ADDENDA

REQUEST FOR PROPOSAL	REQUEST FOR PROPOSALS FOR BIDTITLE: SOUTH END SENIOR CENTER						
		IMPROVEMENTS 830 MAPLE AVENUE					
RFR NUMBER	BIDNO	4986					
DUE DATE	2:00 PM	BIDDATE ****MARCH 9, 2010****

Date	February 26th	2010
Addendum Number	# 1

REQUEST FOR PROPOSALS	FOR SOUTH	I END SENIOR CENTER IMPROVEMENTS
RFR NUMBER	4986	
DUE DATE	2:00 PM	March 4 th , 2010

drawing title: LIGHTING /POWER AT
BACK ENTRY
ADDENDUM #

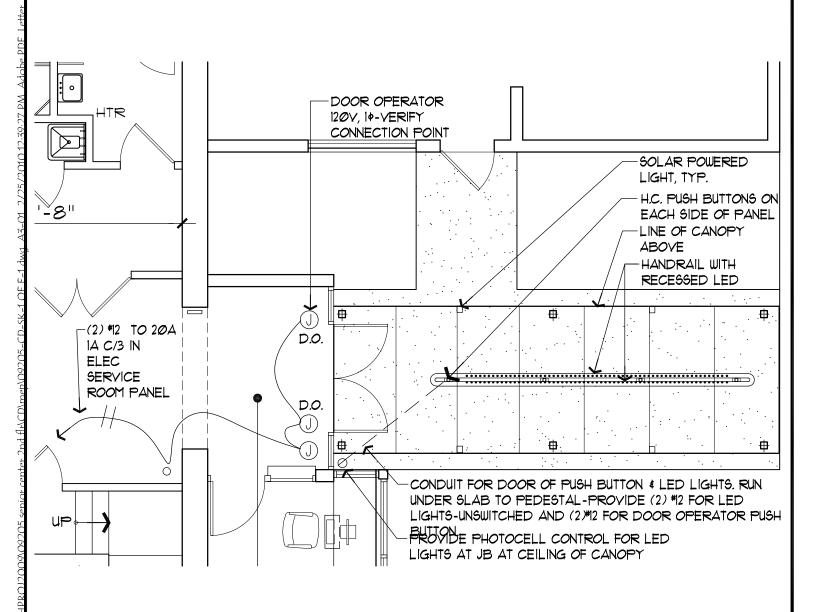
Add Sk-1 Lighting / Power at Back Entry (See attached sketch)
Add Sk-2 Vertical Bar Detail @ HC Bathroom (See attached sketch)
